## PLANNING COMMISISON SITE PLAN – COMPATIBILITY VARIANCES ONLY

**CASE NUMBER:** SP-2021-0102C      **PC HEARING DATE:** May 10th, 2022

**PROJECT NAME:** 1400 Cedar Ave

**Re: Compatibility Setback Waiver**  
**1400 Cedar Ave (SP-2021-0102C)**  
1400 Cedar Ave, Austin, TX 78702

REVISED PROPOSAL

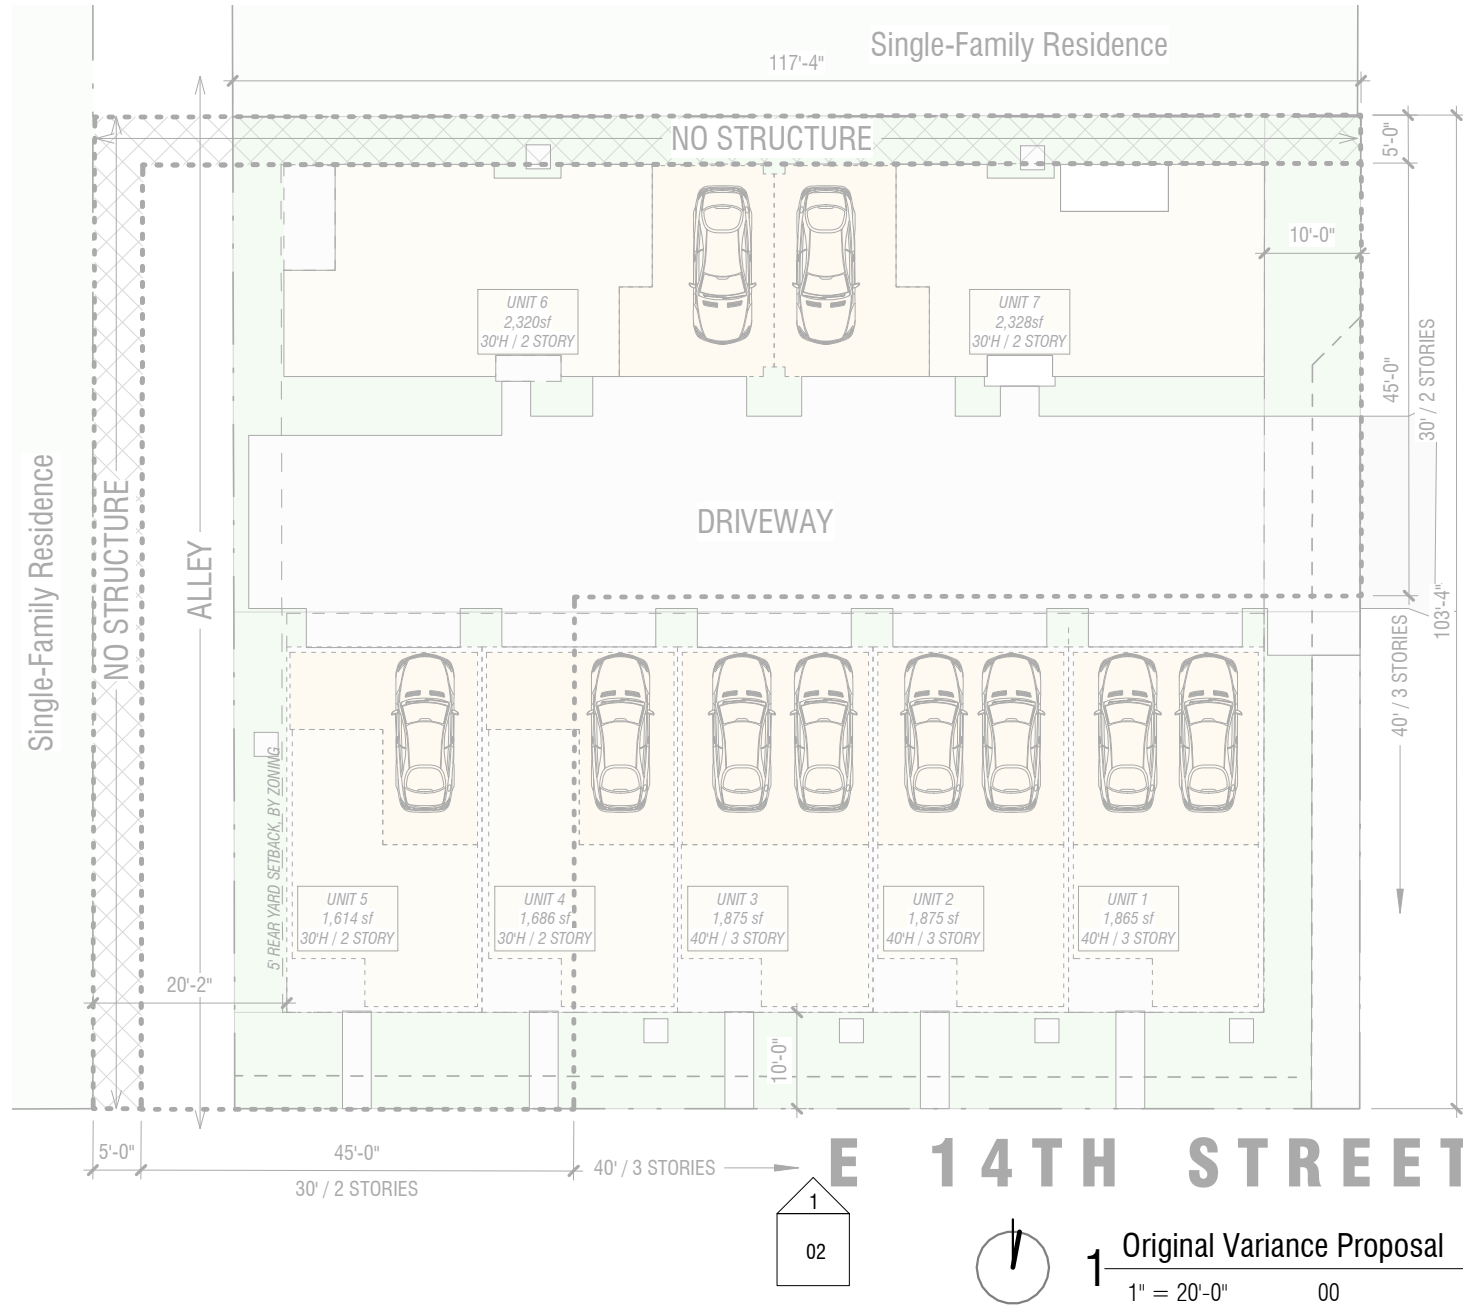
- ELIMINATE 2 UNITS (5 INSTEAD OF 7): REDUCE DENSITY, IMPERVIOUS COVER, AND TRAFFIC IMPACT
  - (EXISTING IMPERVIOUS @ 90-95%, 95% ALLOWED BY ZONING, 75%-80% ANTICIPATED)
- ADDED DISTANCE & IMPROVED SIGHTLINES FROM THE DRIVEWAY TO 14TH & CEDAR INTERSECTION
- INCREASED PARKING PER UNIT (2 EACH)
- 24' FRONT SETBACK WITH PRIVATE YARDS, IN KEEPING WITH NEIGHBORHOOD RESIDENTIAL CHARACTER
- **NO VERTICAL STRUCTURE WITHIN 25' OF NORTH PROPERTY LINE (ON-GRADE IMPROVEMENT ONLY)**
- **20' SETBACK FROM WEST NEIGHBOR ACROSS THE ALLEY**
- **35' & 3 STORIES ALLOWED WITHIN THE BUILDABLE AREA**

1 Site Section N/S  
1/8" = 1'-0" 01

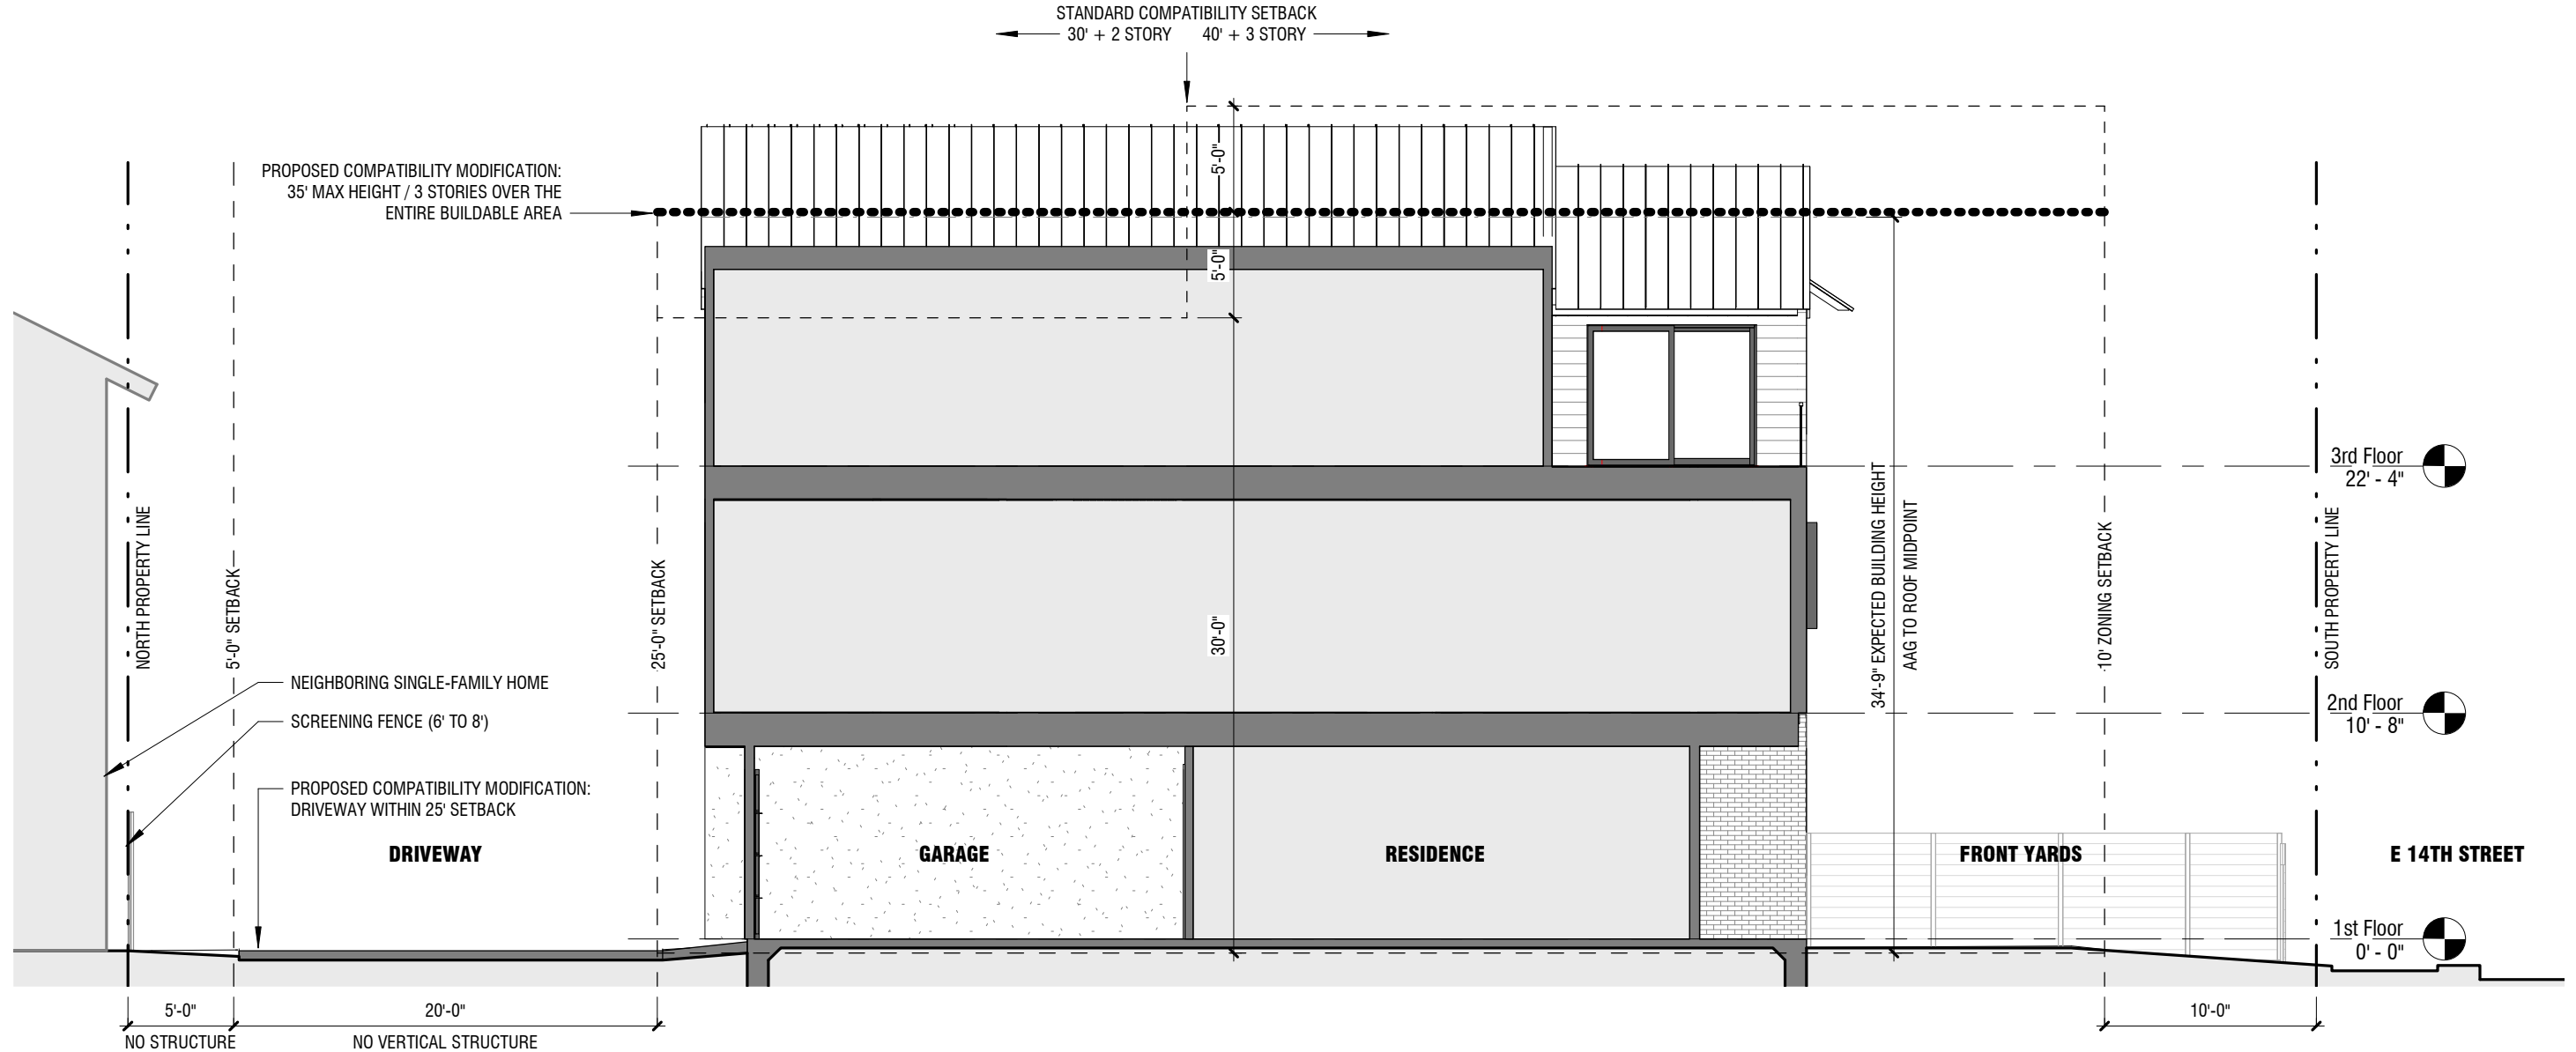
**Request: Allow to reduce the 25' no build setback to 5'**  
**Allow to increase height from 30' or 2 stories to 36' or 3 stories within the 50' setback [LDC 25.2.1063].**

We would like to request that the compatibility standards are modified to reduce the no build zone from 25' to 5' and increase the height limitation from 30' or 2 stories height limitation to 36' or 3 stories from 5' to 50' from the properties triggering compatibility, and so forth. Attached to this letter is the proposed building elevations sheet.

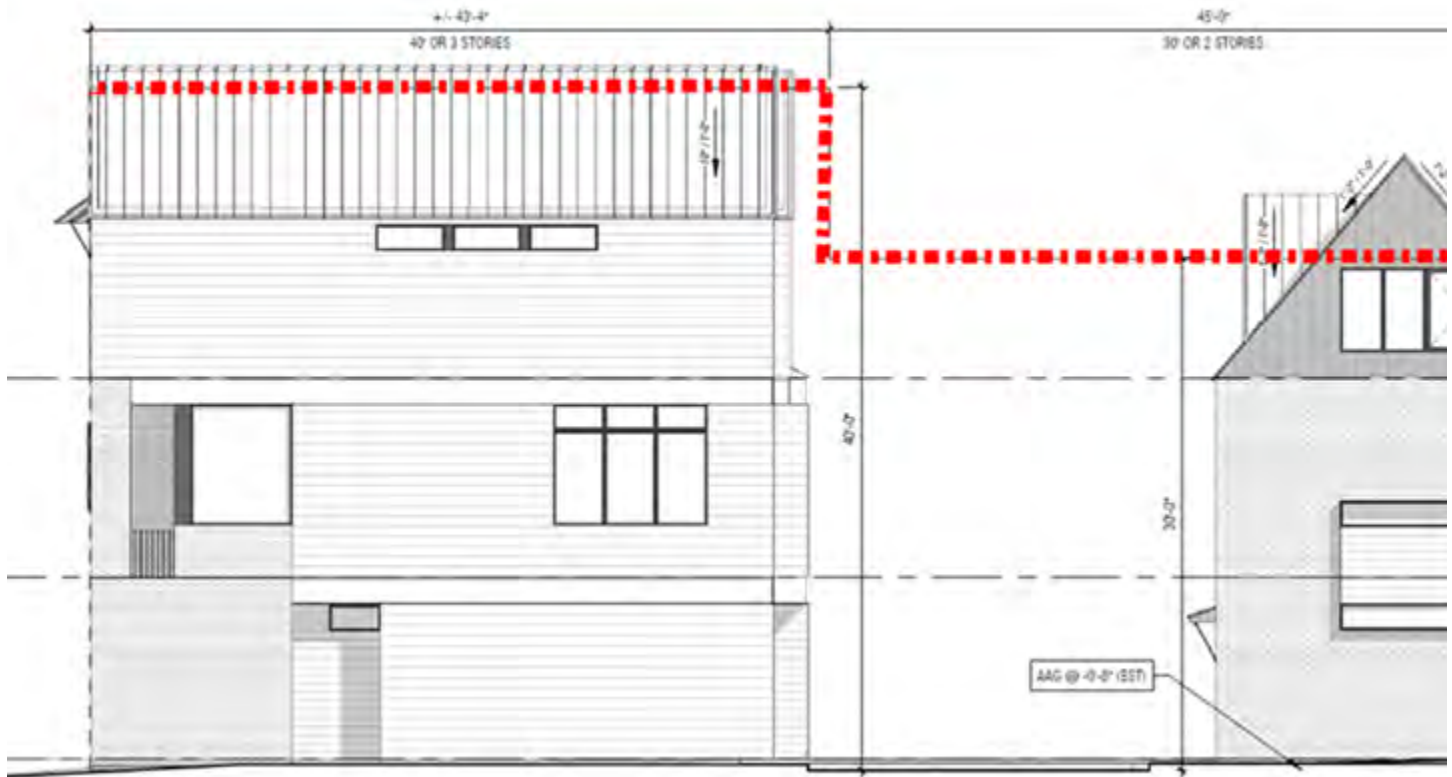
Hi Zack- Thanks for the explanation. As for the height, the exhibit seems to clearly show that they are exceeding the compatibility tent- see below. What am I missing? Thanks,

You are correct that this waiver is only for compatibility setbacks. The proposed development complies with the compatibility height regulations - this is shown in the background materials. I do realize that it's fairly nitty-gritty so let me know if you'd like to have a call to discuss it in more detail.
